APPLICATION NO.	FILING DATE	FIRST NAMED INVENTOR	ATTORNEY DOCKET NO.	CONFIRMATION NO.
10/516,471	11/29/2004	Rabih Moughelbay	CU-5962 5737	
26530 LADAS & PAI	7590 12/13/2007 RRY LLP		EXAMINER	
224 SOUTH M	IICHIGAN AVENUE	MENEZES, MARCUS		
SUITE 1600 CHICAGO, IL 60604			ART UNIT	PAPER NUMBER
0.1.01.00,12			3677	
			MAIL DATE	DELIVERY MODE
			12/13/2007	PAPER

Application No.	Applicant(s)				
	10/516,471	MOUGHELBAY ET AL.				
Office Action Summary	Examiner	Art Unit				
	Marcus Menezes	3677				
The MAILING DATE of this communication appears on the cover sheet with the correspondence address Period for Reply						
A SHORTENED STATUTORY PERIOD FOR REPLY IS SET TO EXPIRE 3 MONTH(S) OR THIRTY (30) DAYS, WHICHEVER IS LONGER, FROM THE MAILING DATE OF THIS COMMUNICATION. - Extensions of time may be available under the provisions of 37 CFR 1.136(a). In no event, however, may a reply be timely filed after SIX (6) MONTHS from the mailing date of this communication. - If NO period for reply is specified above, the maximum statutory period will apply and will expire SIX (6) MONTHS from the mailing date of this communication. - Failure to reply within the set or extended period for reply will, by s

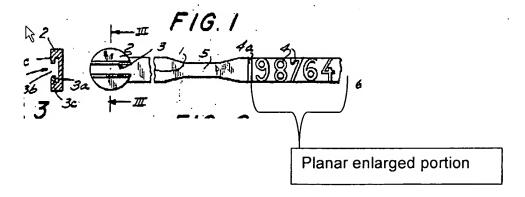
Claims 70-72 and 80-82 are rejected under 35 U.S.C. 102(b) as being clearly anticipated by Schumm (US 3,147,522).

Regarding claim 70, Schumm discloses a system comprising a respective tying device, wherein each tying device comprises an elongate member (1) for releasable securement at a cable by wrapping around the cable; a planar enlarged portion arranged on the member for insertion through a hole (3a) in the member, the enlarged portion including a raised portion (4) thereon to provide that part of the enlarged portion with a thickness greater than a remainder (5) of the enlarged portion; wherein the device being configured such that the enlarged portion can be passed from one side of the member, completely through the hole, to an opposite side of the member to be secured at the opposite side; and wherein the elongate member has the same thickness as the remainder of the planar enlarged portion. (See figures 1 and 2 and below).

Regarding claim 80, Schumm discloses a card (fig. 16) comprising a plurality of detachable elongate members, each of the members being frangibly joined to the card for detachment therefrom, an enlarged portion being defined in at least one of the members for insertion in use through a hole (3a) located in the member, the enlarged portion being connected to at least one elongate member (7) and being inserted through a hole located in the member; wherein the enlarged portion has a transverse width greater than a corresponding transverse width of the hole. (See figure 5 below).

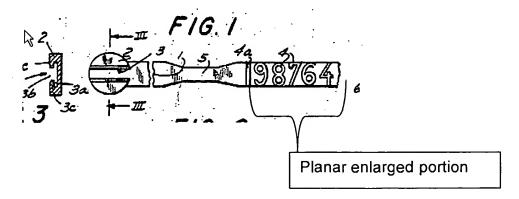
Claims 85-87 are rejected under 35 U.S.C. 103(a) as being unpatentable over Schumm.

Regarding claim 85, Schumm discloses a card (fig. 16) comprising a plurality of detachable elongate members, each of the members being frangibly joined to the card for detachment therefrom, an enlarged portion being defined in at least one of the members for insertion in use through a hole (3a) located in the member, the enlarged portion being a planar enlarged portion arranged on the member for insertion through a hole located in the member, and the enlarged portion including a raised portion (4) thereon to provide that part of the enlarged portion with a thickness greater than a remainder of the enlarged portion. (see figure below)

However, Schumm states that the enlarged portion has a transverse width substantially the same as a corresponding transverse width of the hole. It should be noted that substantially is a broad term and that the friction between the side walls of the hole and the enlarged portion is necessary in order for the device to function properly; thus it would have been obvious to one having ordinary skill in the art at the time the invention was made to have included in Schumm an enlarged portion having a transverse with that is greater than the corresponding transverse width of the hole in order to impart friction between the hole side walls and the enlarged portion.
